39 Great James Street
125 DOC B29 - Discharge of Conditions

March 2019

This document outlines the proposed strategy for discharging conditions at no. 39 Great James Street under listed building consent 2016/6155/L, which is related to planning consent 2016/5124/P.

Roof Structure: Alternative Scheme

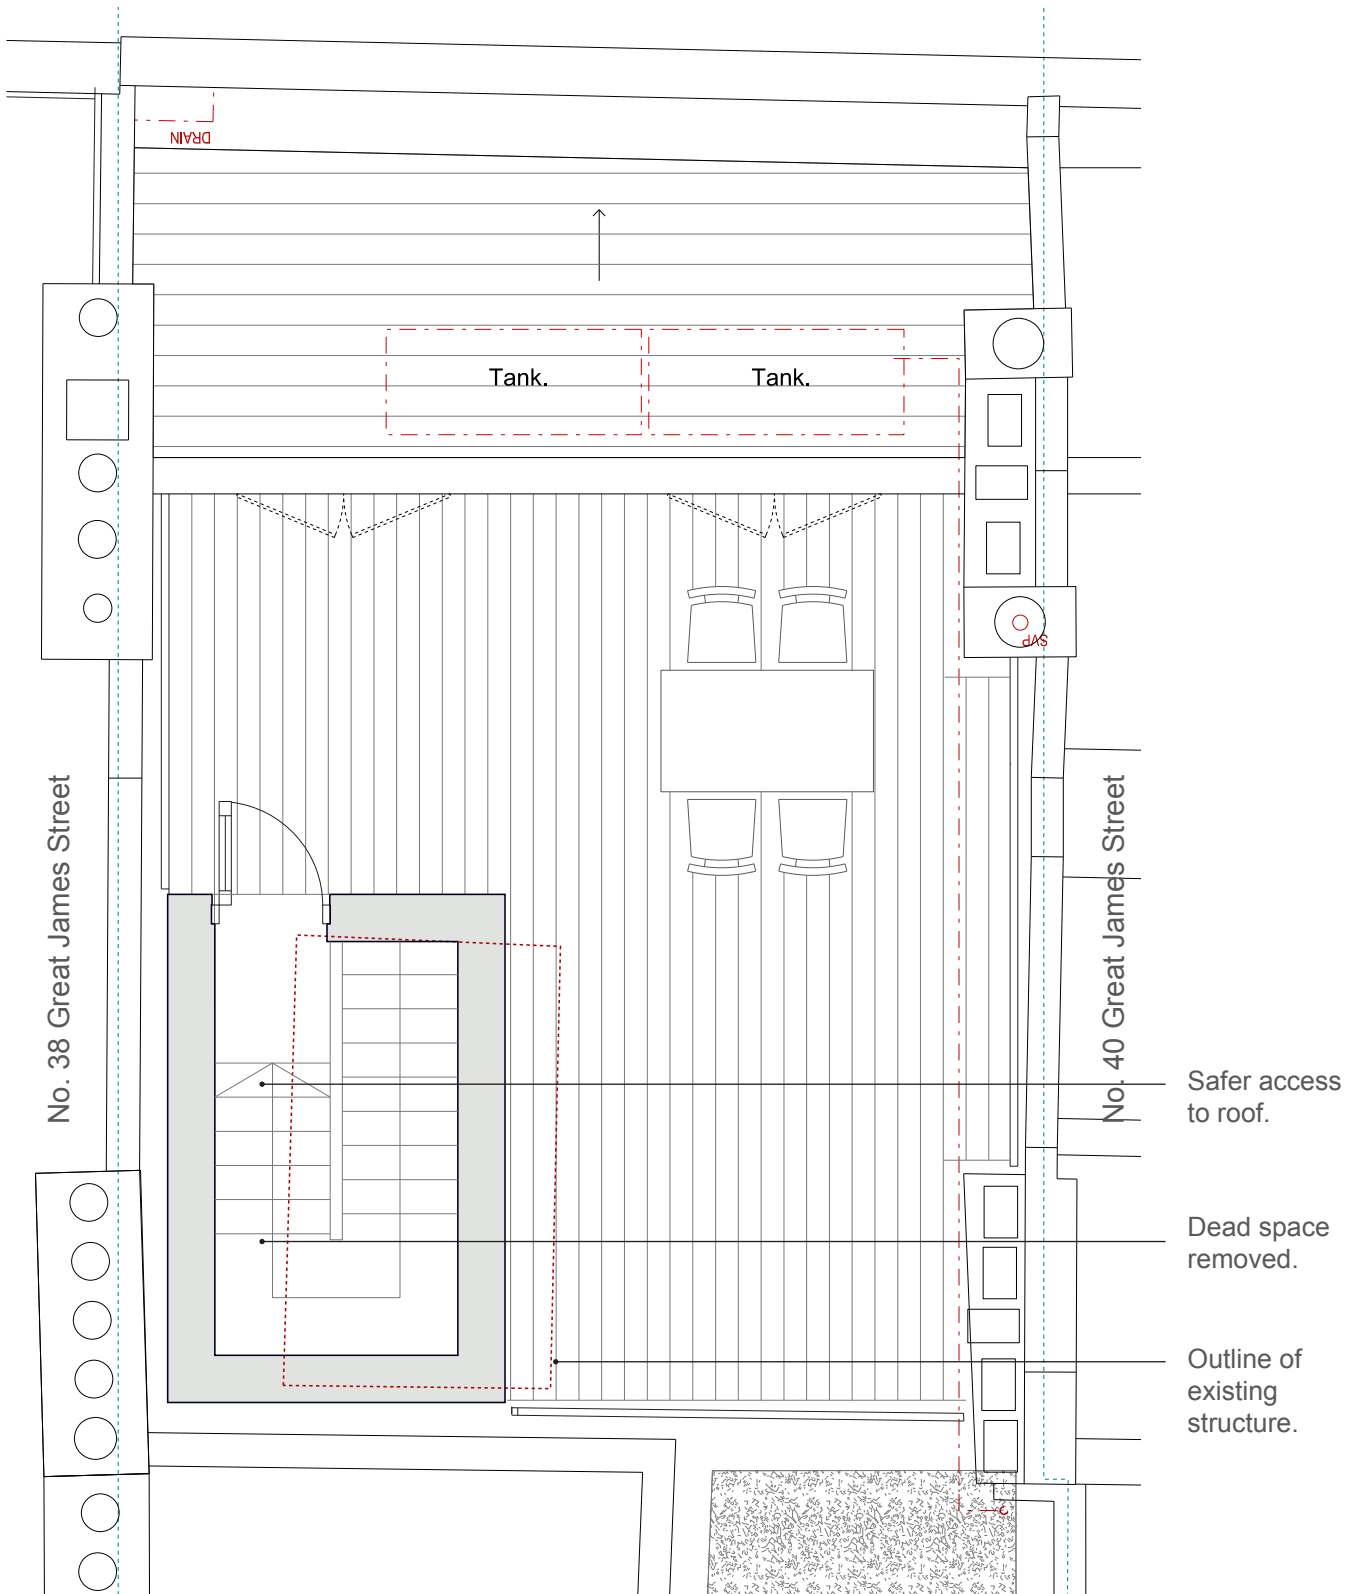
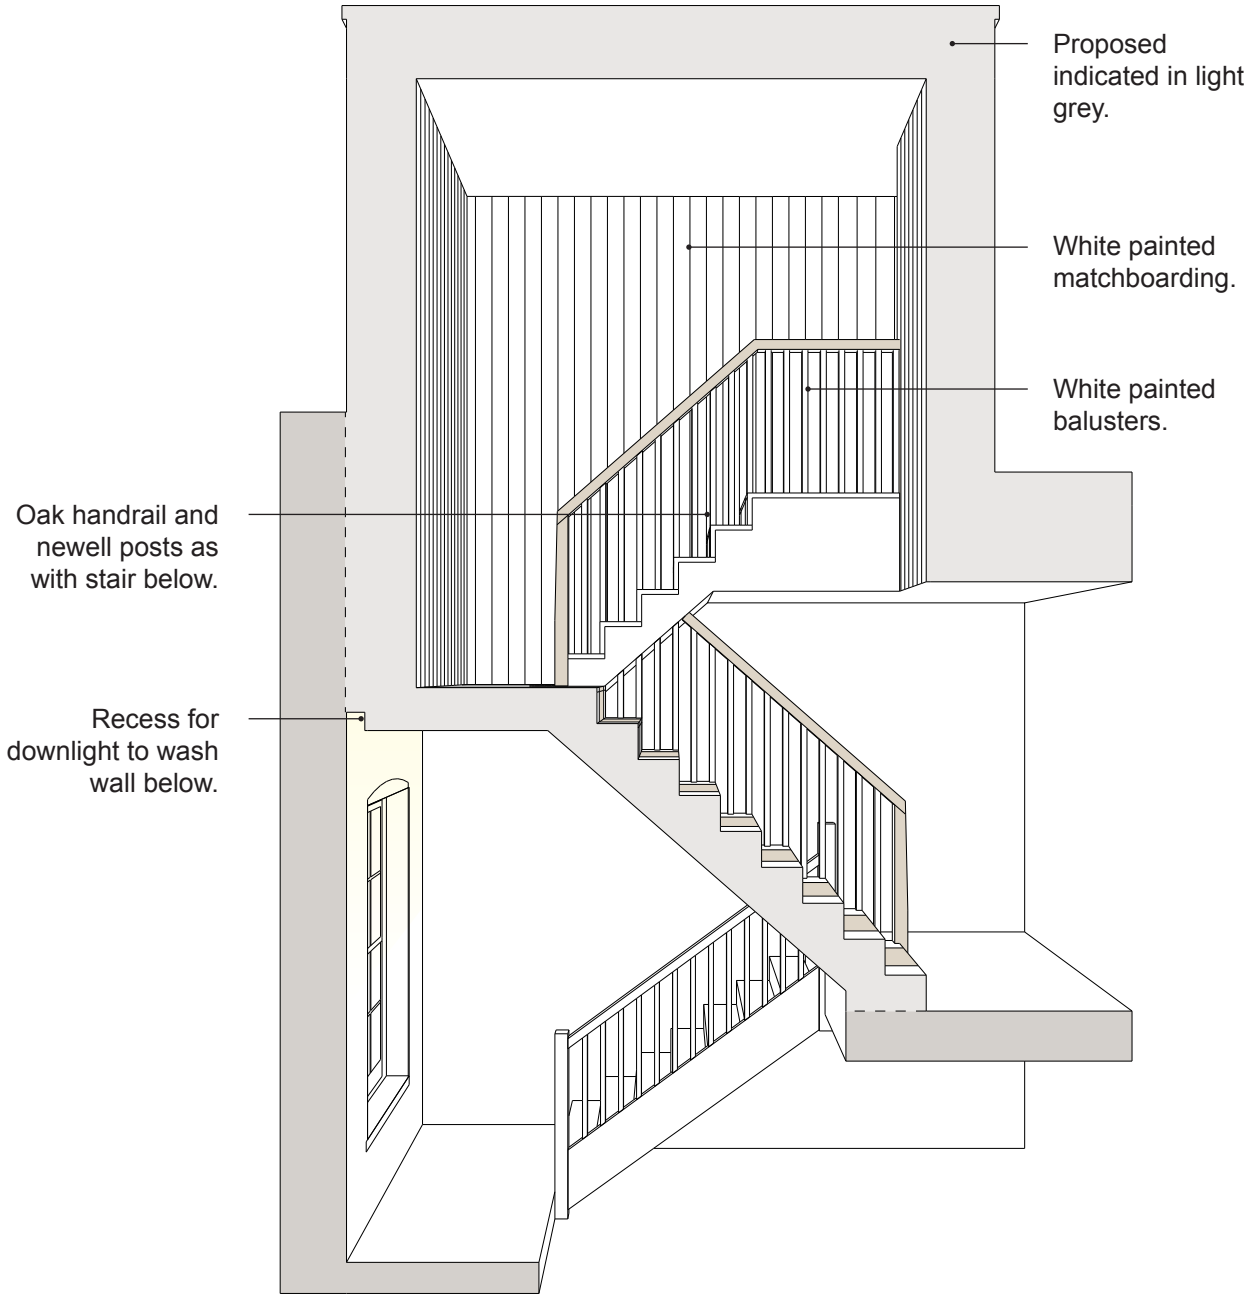
A revised stair and roof access structure is therefore proposed. In order to ensure the revised stair is compliant with current regulations, a replacement roof structure is required. This roof structure results in a more rational layout to the roof terrace, as indicated overleaf by the current and alternative roof plan.

The roof structure will be clad externally in timber to match the adjacent decking. This will weather a silvery grey and have a softer appearance than the existing zinc clad structure.

The proposed roof structure will not exceed the height of the neighbouring timber roof pergola at no. 38 Great James Street.

View from Third Floor to Proposed Stair

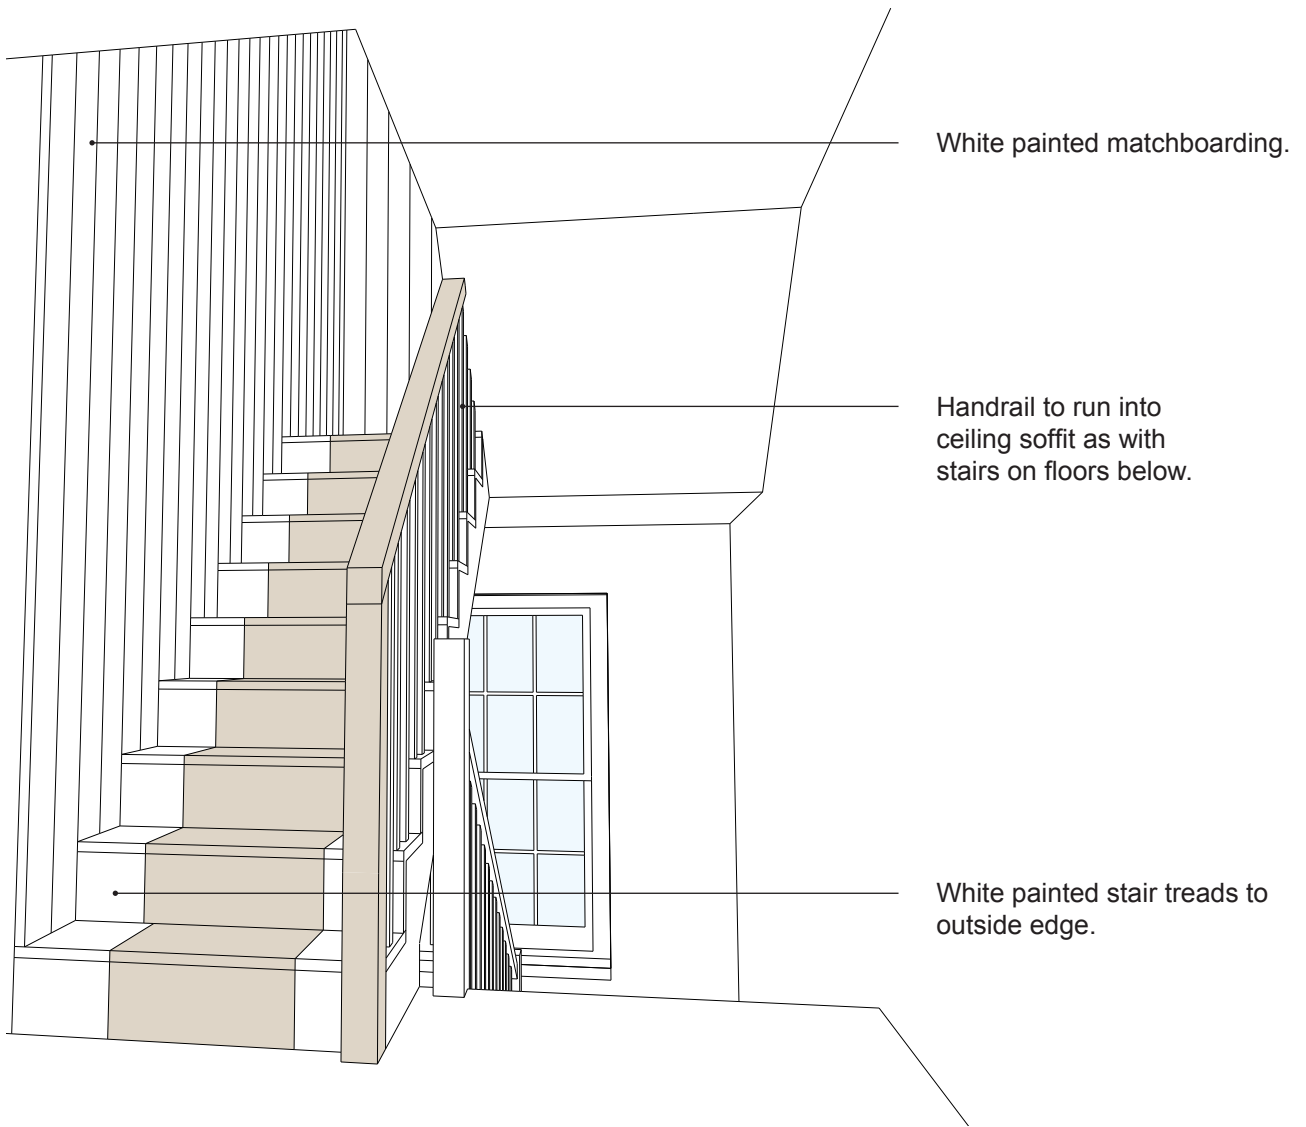
I am not mad about the handrail and newel detail but otherwise happy

Attached here is SK 31 showing interior views of the stair, indicating how it is arranged overall and how the balustrade and will be executed. We have simplified the layout to have straight flights and landings as below. The stairs will be softwood with white painted matchboard sides. The white paint will cover the edges of the stairs too. The handrail will be hard wood and shall be expressed, as the original are downstairs.

Overall the aim is to pick up on the detailing of the original stair but to render the detail in a much planer fashion to articulate the new form the old and to follow the general pattern of less embellishment as one proceeds to the upper areas.
